Addendum #1

Attn: Estimator	Date: November 14, 2024
From: Lisa Donahue, Project Administrator	Pages: 58 (including cover page)
Re: Bullock Creek School District 2024 Bond Series 1	Project: 2025 Summer Projects HS/MS/Elem/Pine River/Floyd and Maintenance Building
CC:	Proj. #: A24907

Project: No. 24-120 2023 Bond – Series 1 2025 Improvements

Issue Date: November 14, 2024

SEAL	DRAWN	PROJECT NO.
	EVA	24-120
	CHECKED	CAD FILE NO.
	JESS	F-A104
	REVIEWED	DRAWING NO.
	MLB	F-A104
	DATE	SHEET NO.
	OCT 18, 2024	9 OF 13
	SCALE	
	AS NOTED

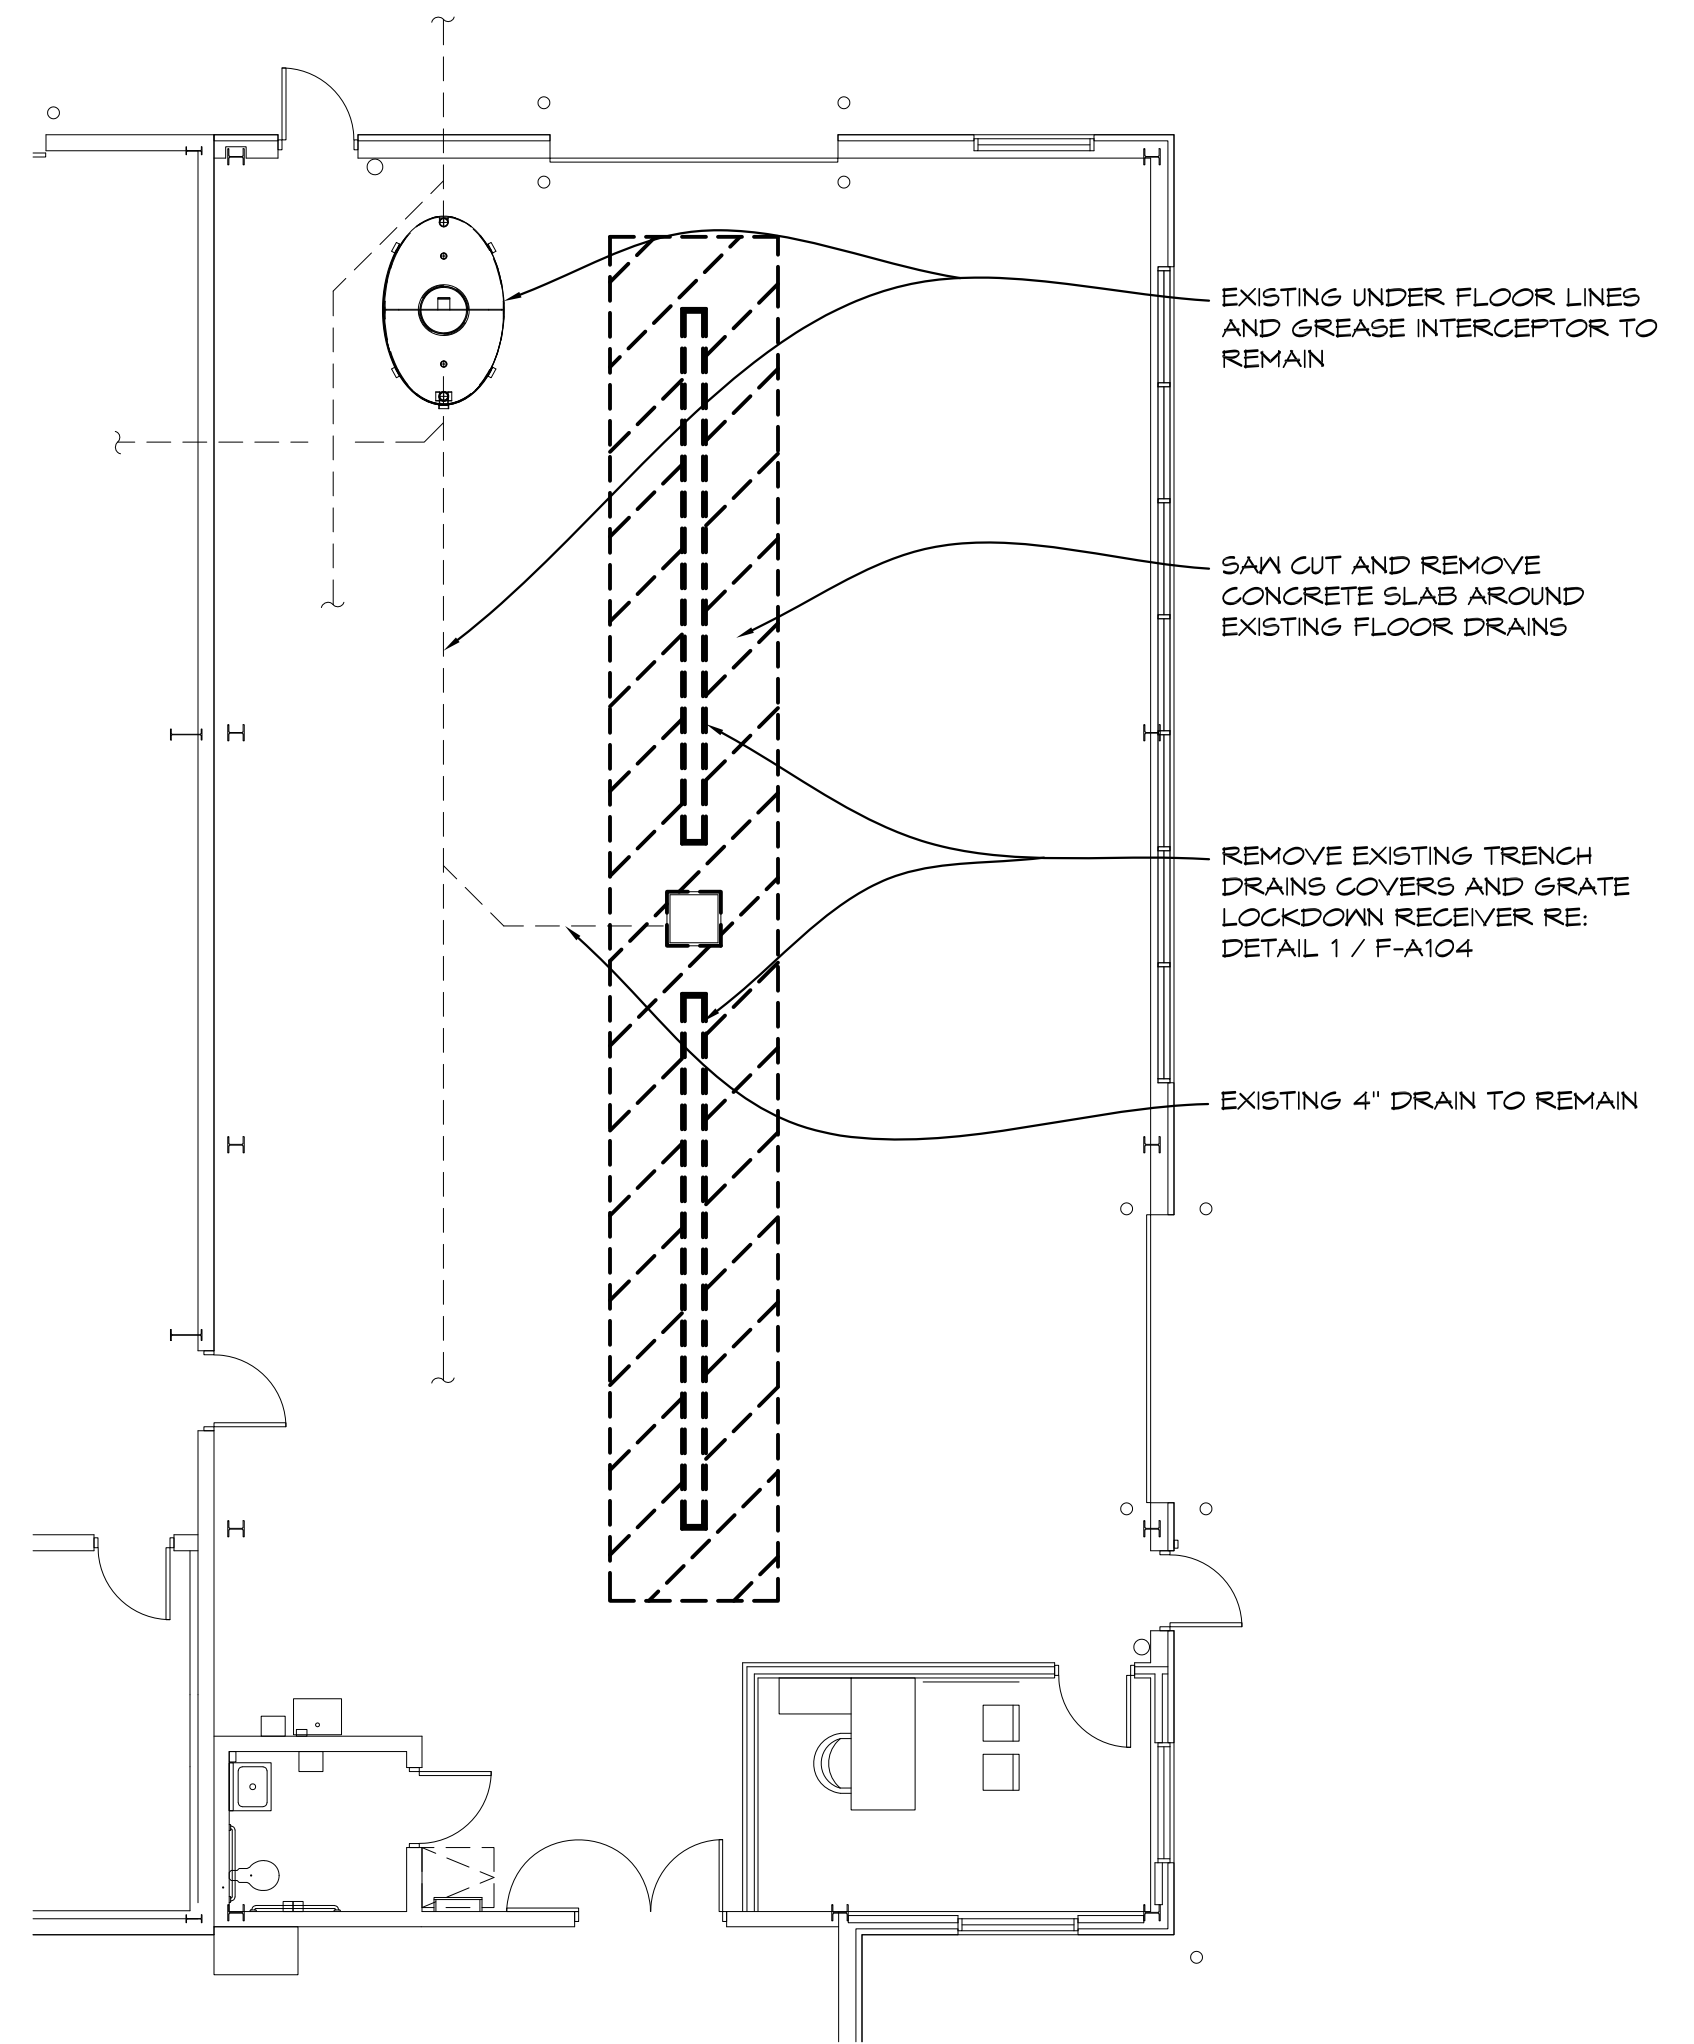
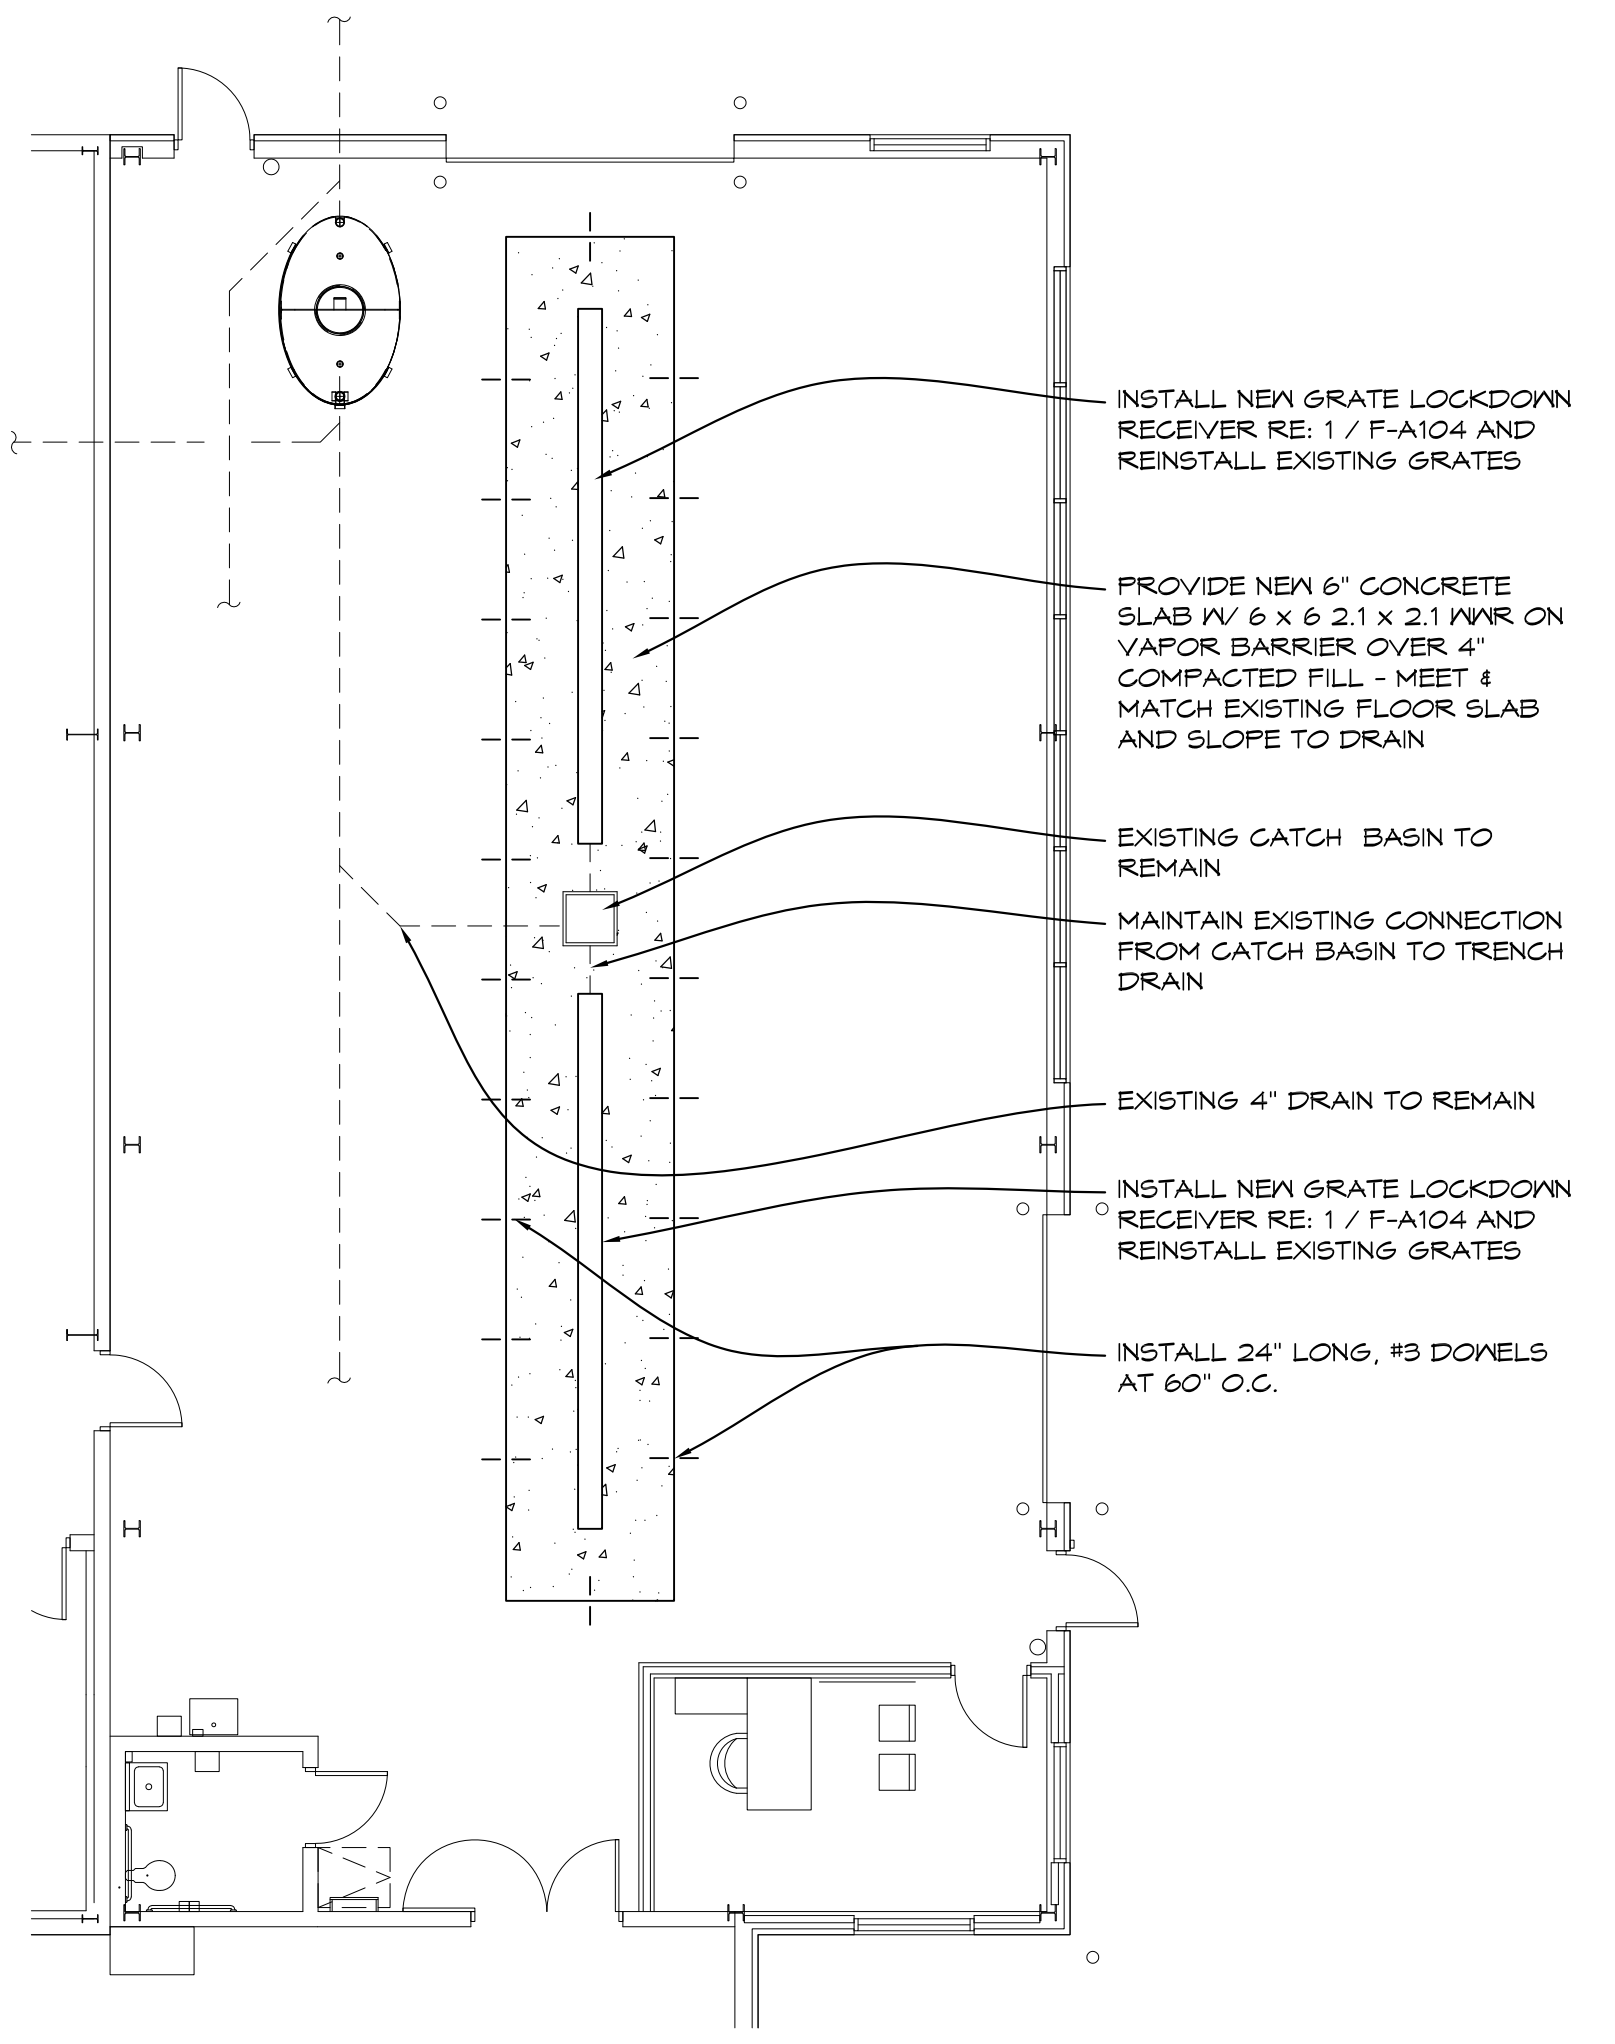
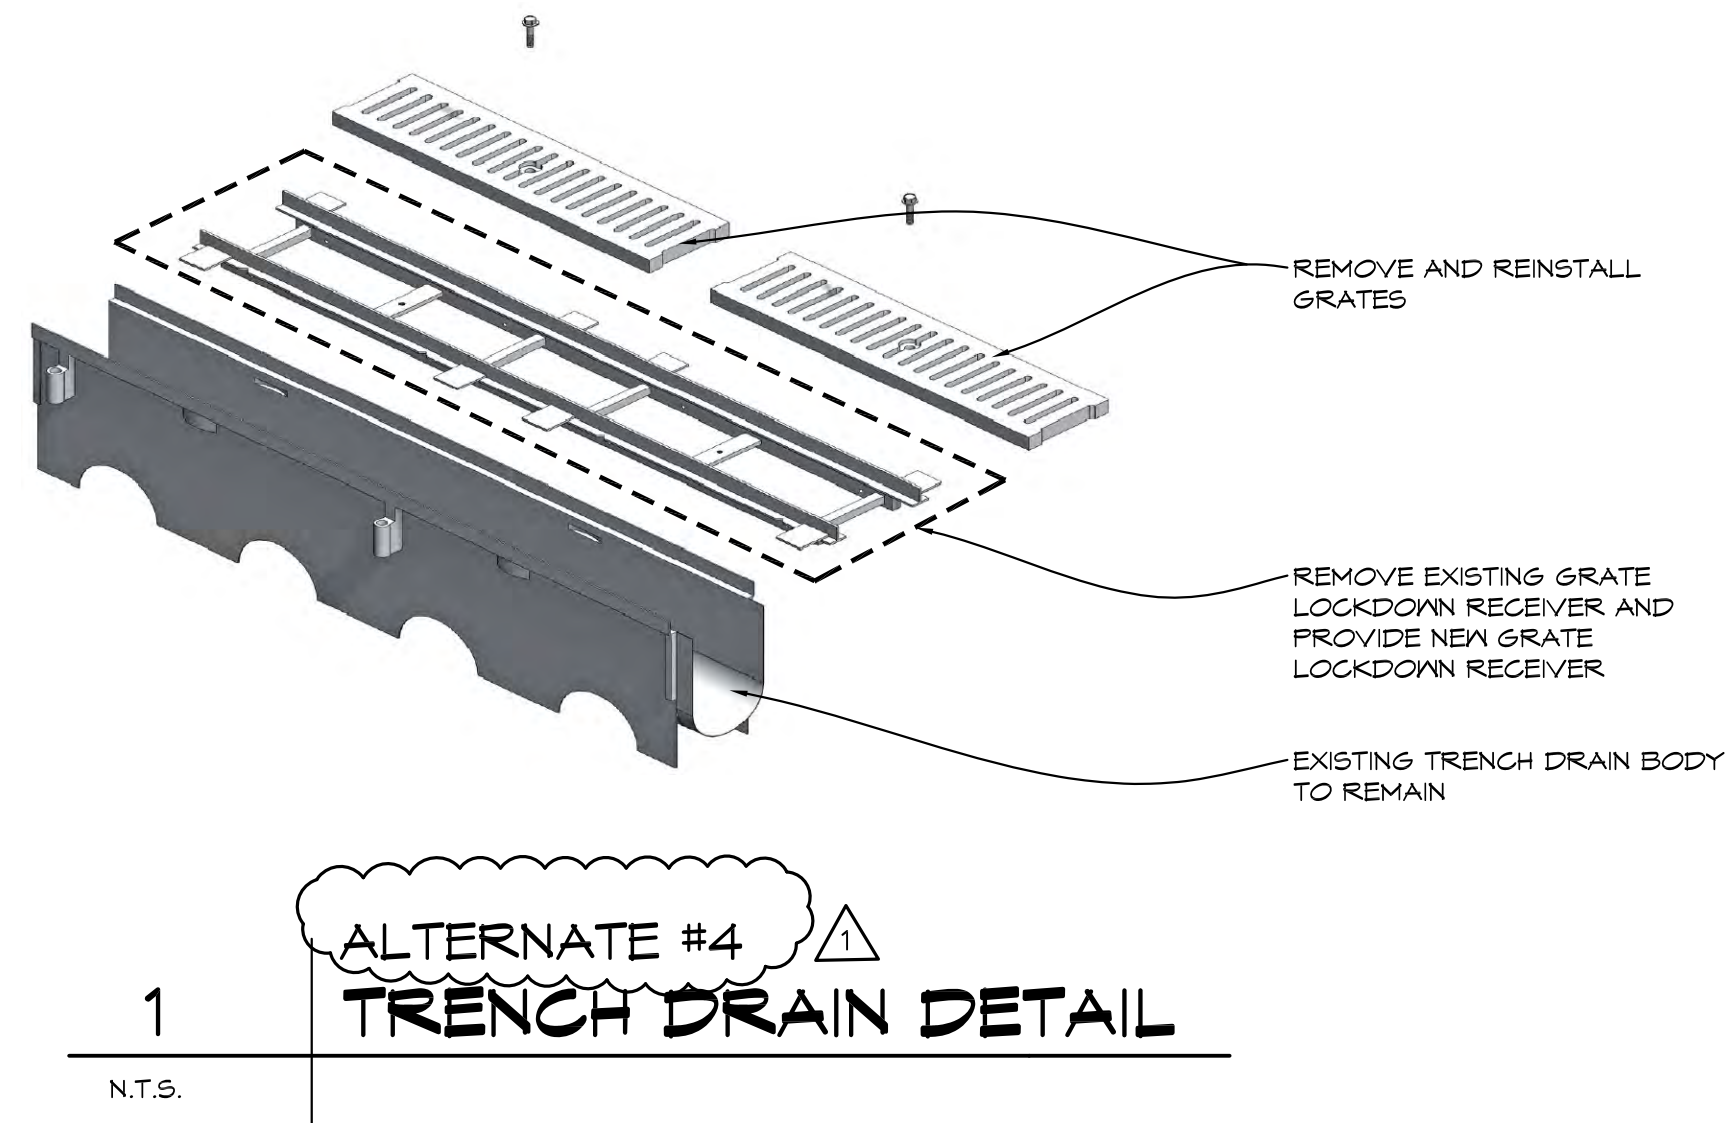
Item #A3: Revise Sheet F-A104 as follows:
a. Revised to show all work on this Sheet as Alternate #4.
